## NOTICE OF APPROVAL

**Planning Case #:** Design Study 21079

CITY OF CARMEL-BY-THE-SEA  
DEPARTMENT OF COMMUNITY PLANNING AND BUILDING  
FINDINGS AND CONDITIONS FOR DESIGN STUDY APPROVAL

DS 21-079 (Hotvet)  
Torres Street, 5 NE of 8th Avenue  
Block: 100, Lot: 12  
APN: 010-053-006

**SITE PLAN**  
SCALE: 3/16" to 1'-0"

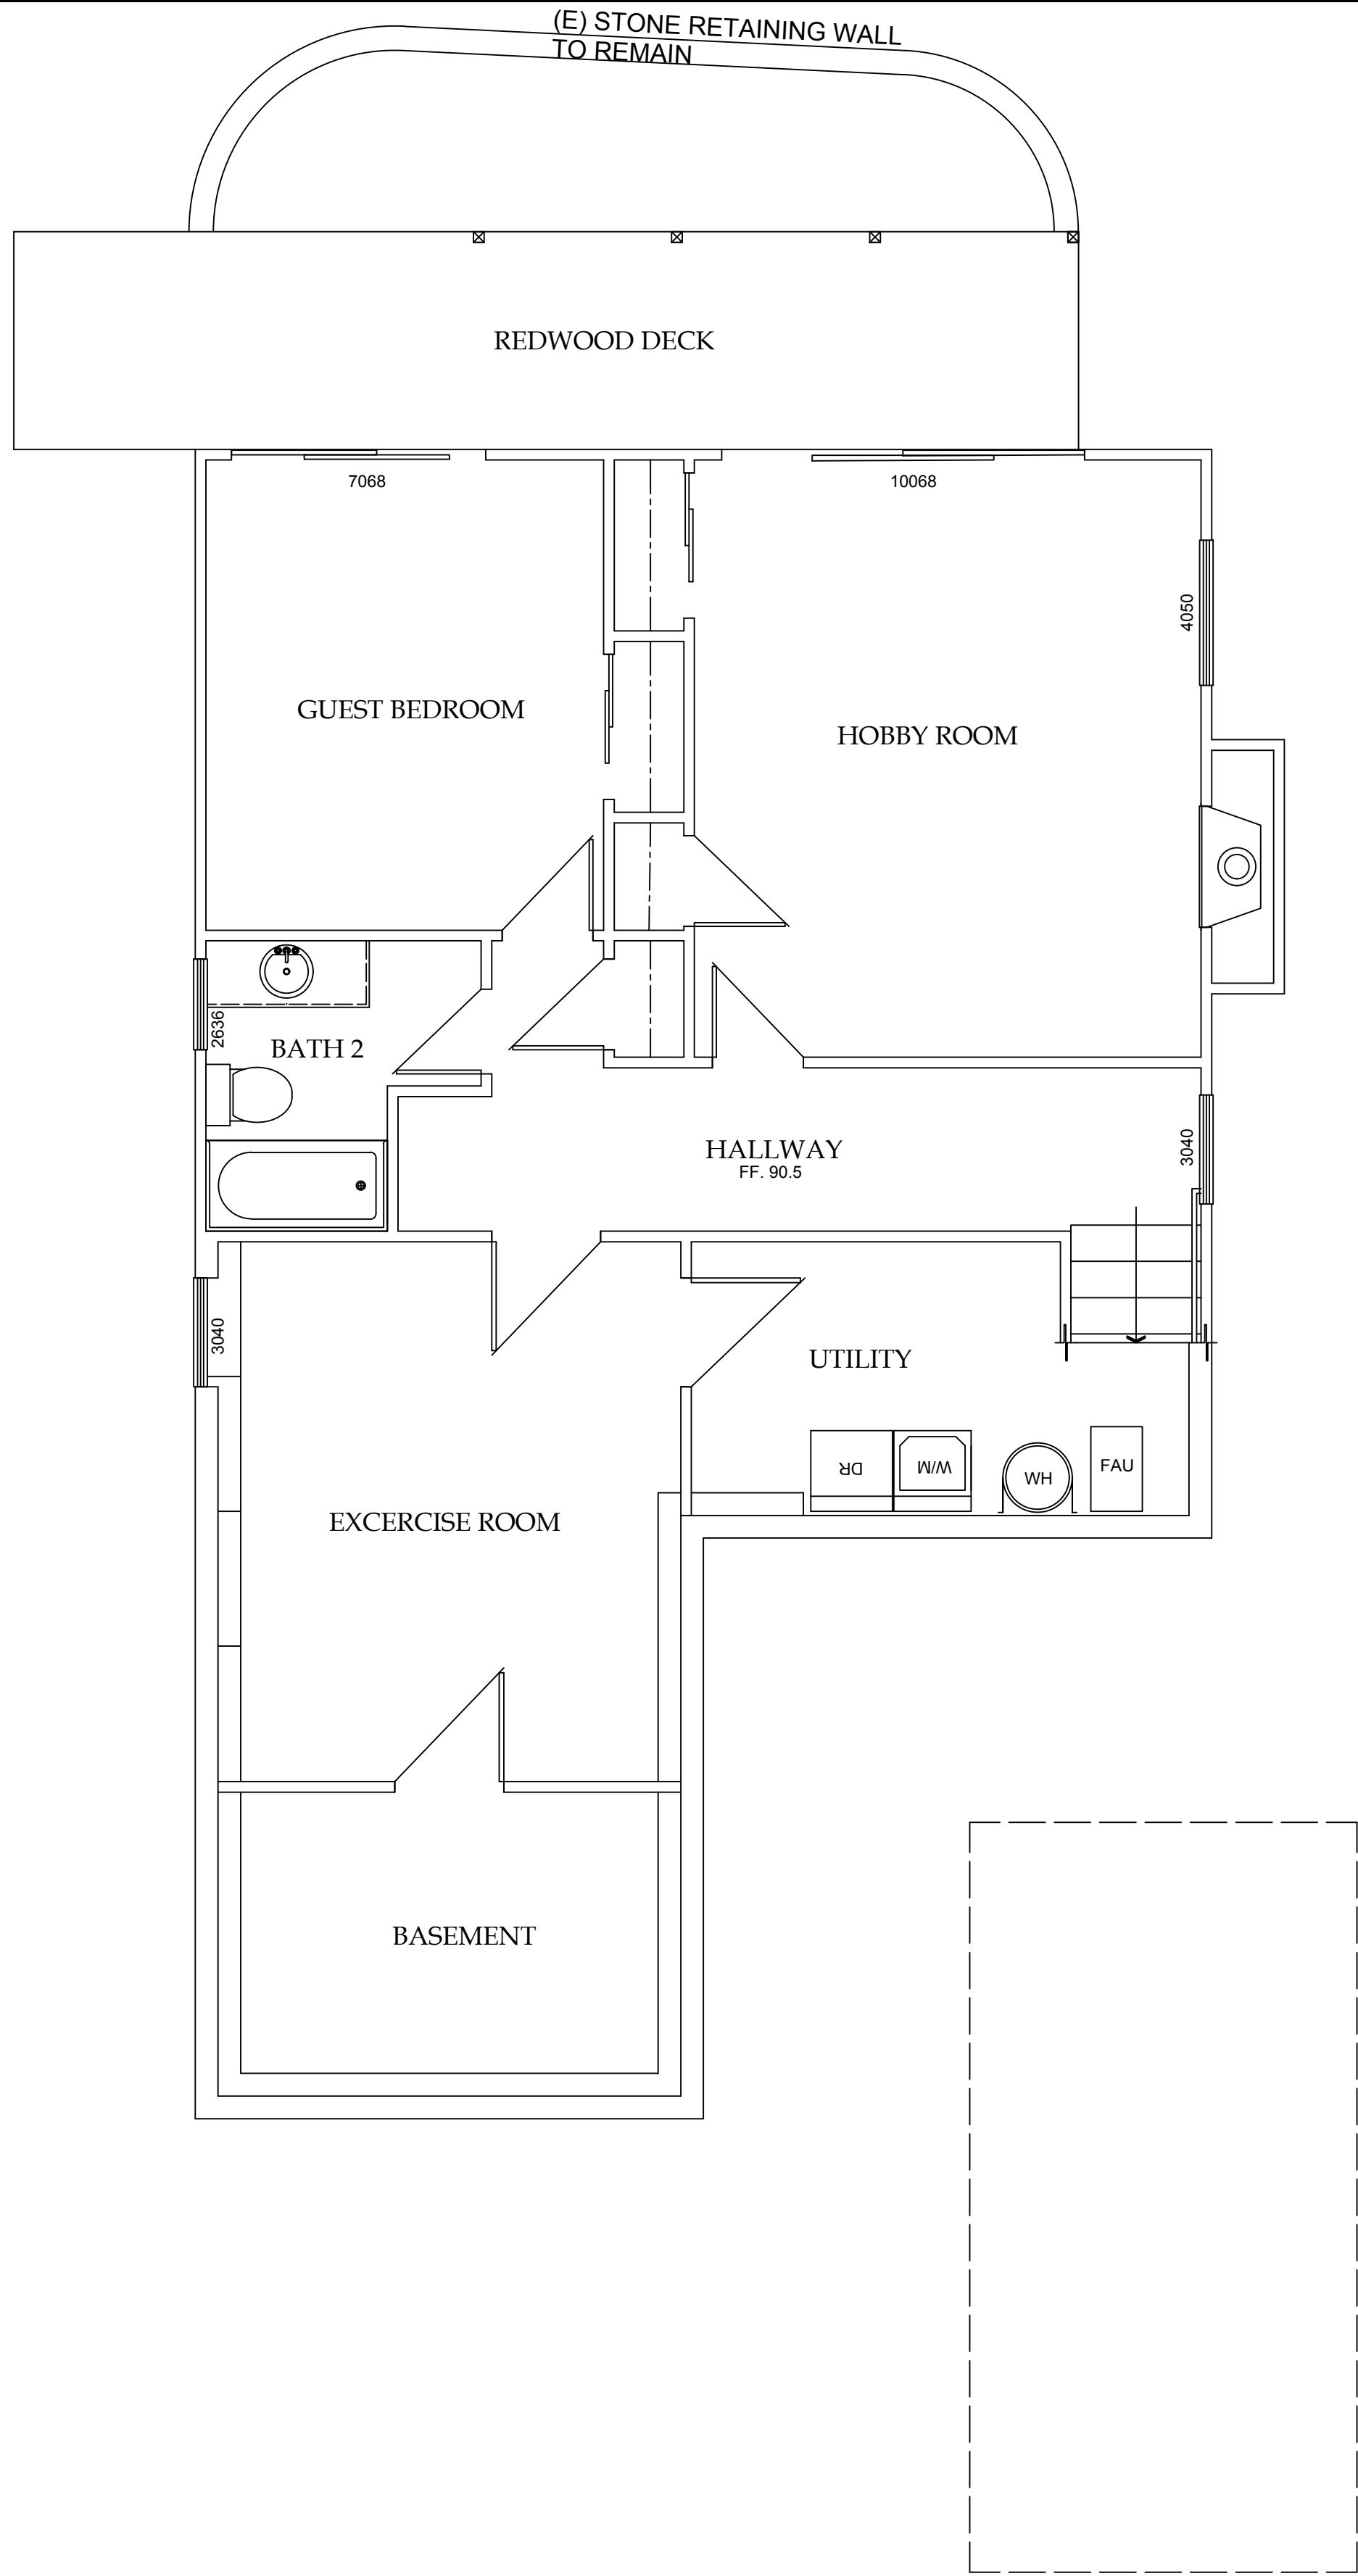
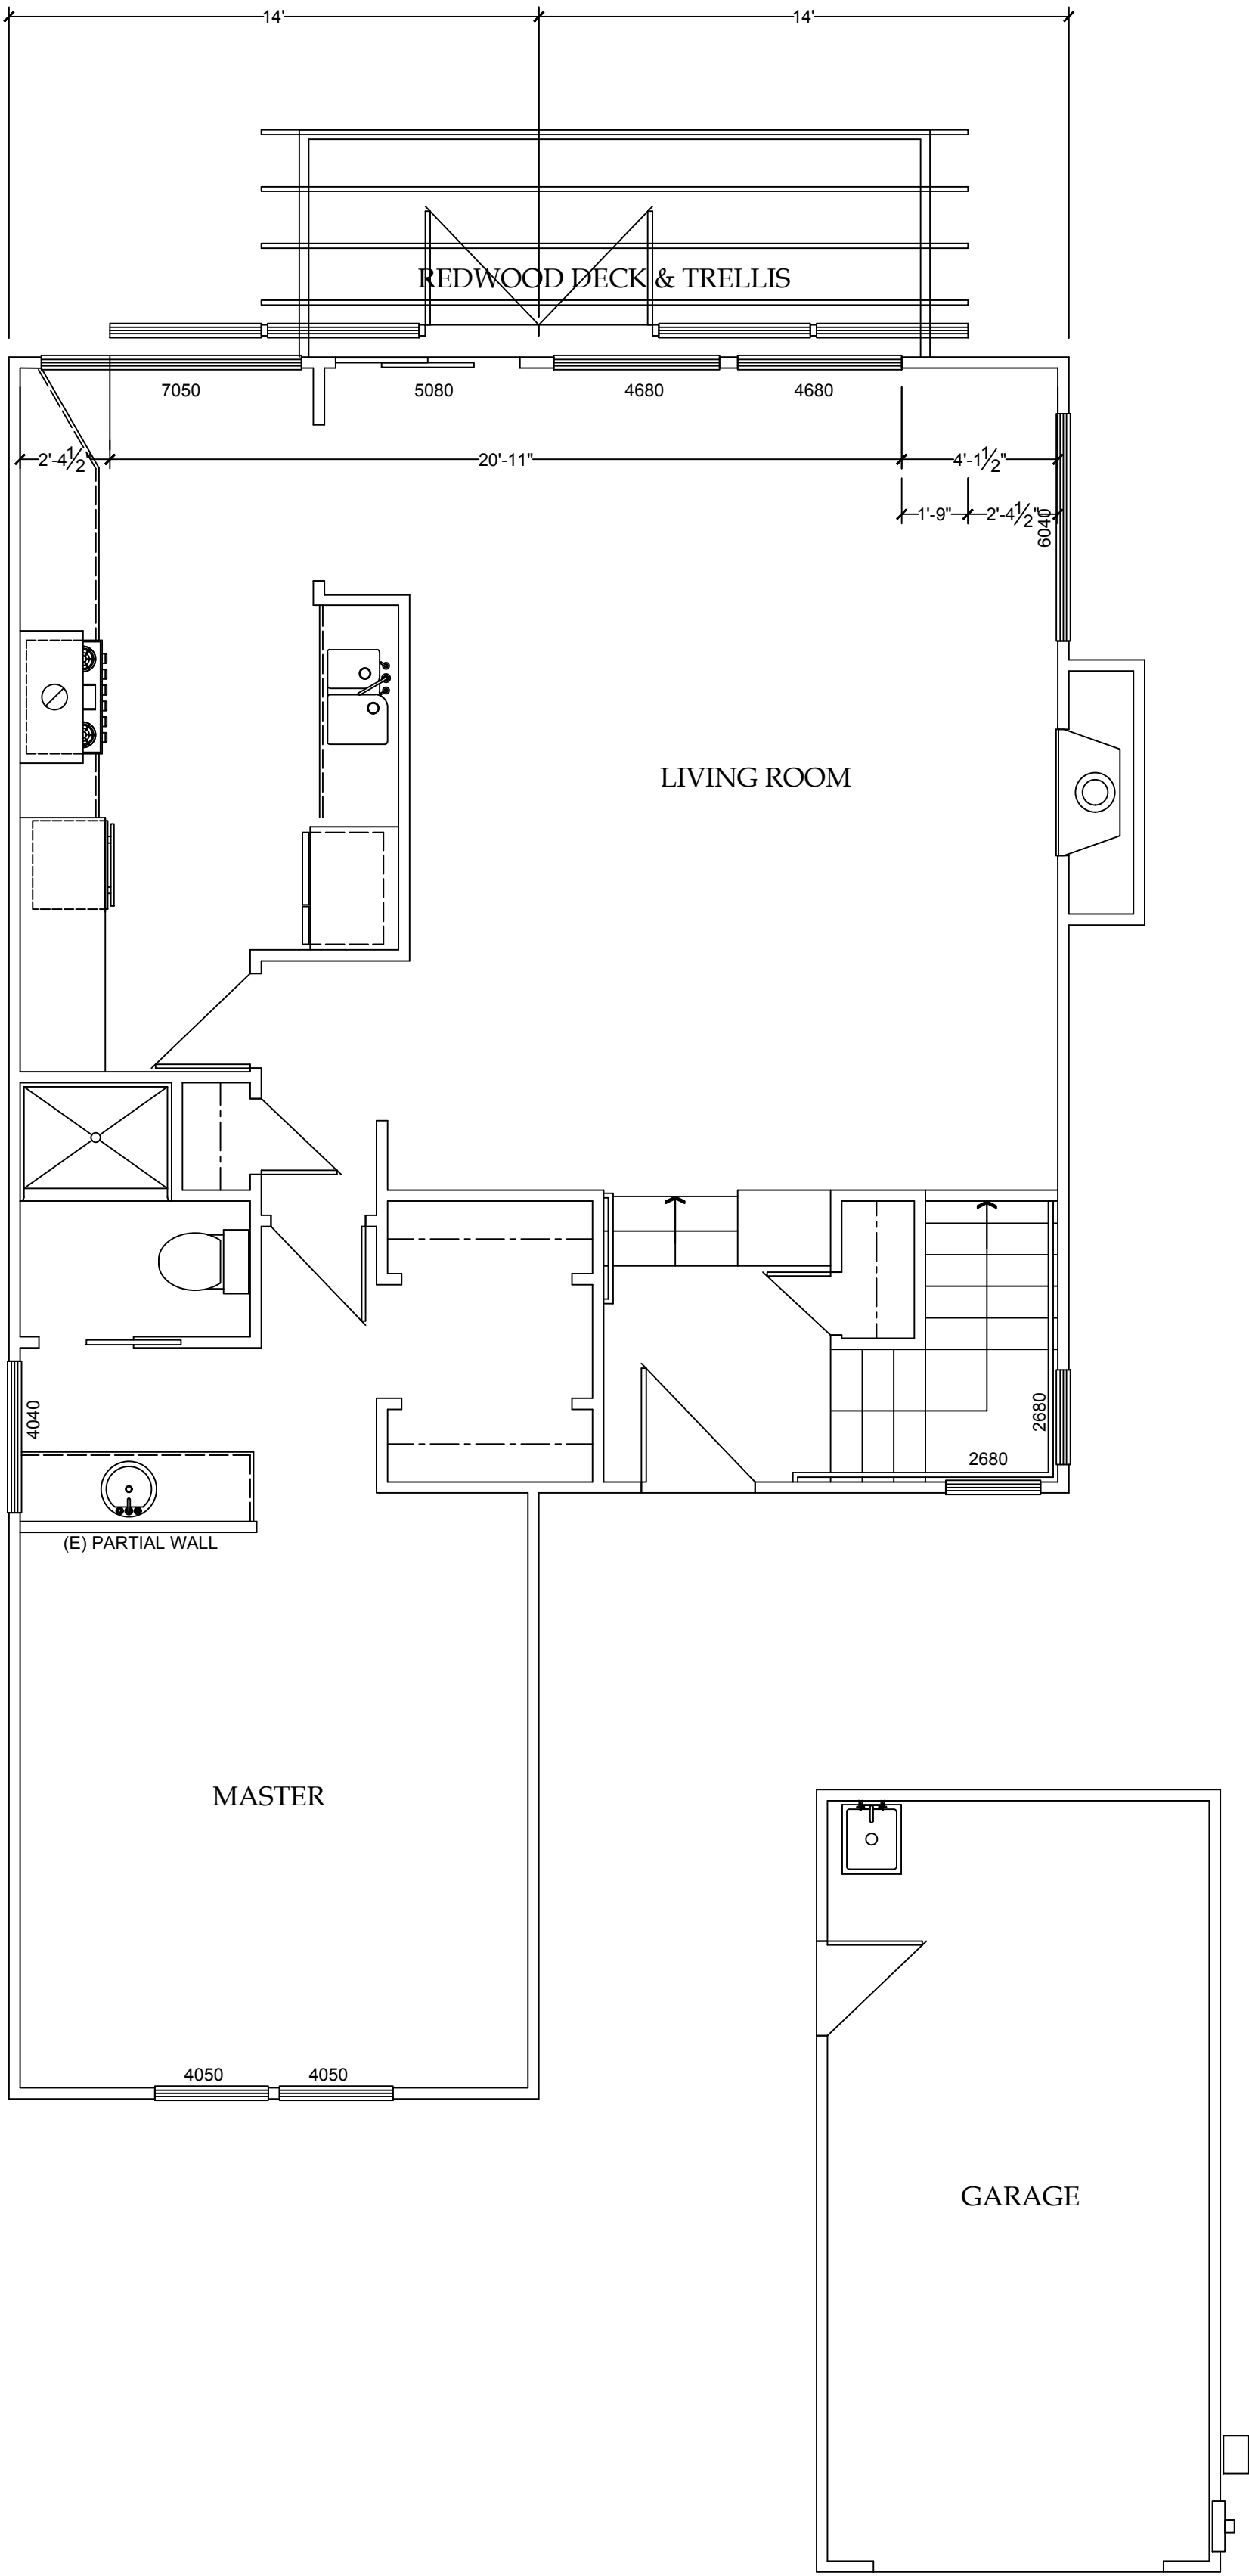
29.	<b>Site Plan Revision.</b> Prior to building permit issuance, the site plan (sheet A1) shall be revised so the deck area is consistent with the new deck area represented on the proposed floor plan (sheet A2). Also see Condition of Approval #26, above.	✓

**NORTH ELEV.** GARAGE NOT SHOWN  
SCALE: 1/4" to 1'-0"

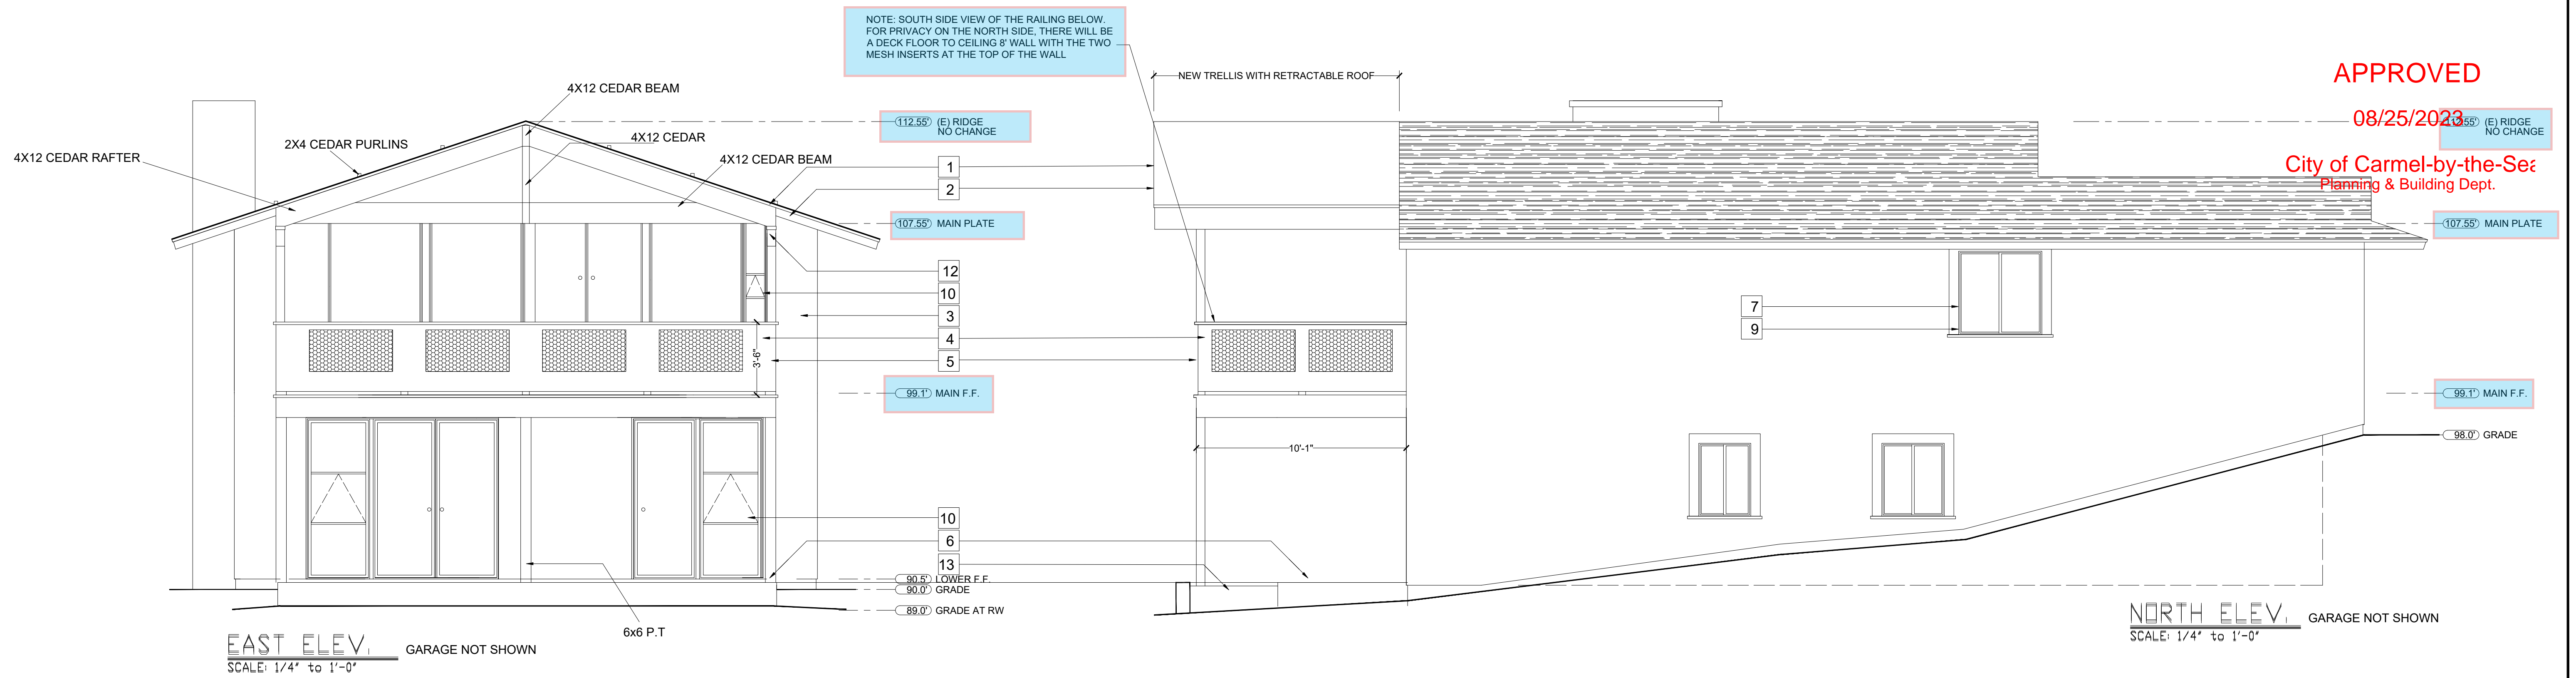
27.	<b>Rear Deck Screening.</b> A privacy screen shall be maintained on the north elevation of the rear deck, as depicted in the approved project plans. At a minimum, the top screen shall reach a height of 6' above the walking surface of the deck. Details of the screen wall shall be maintained in the plan set submitted to the building division. The screen wall shall be maintained for the life of the structure unless written approval is granted to remove the screen by the Community Planning and Building Department.	✓
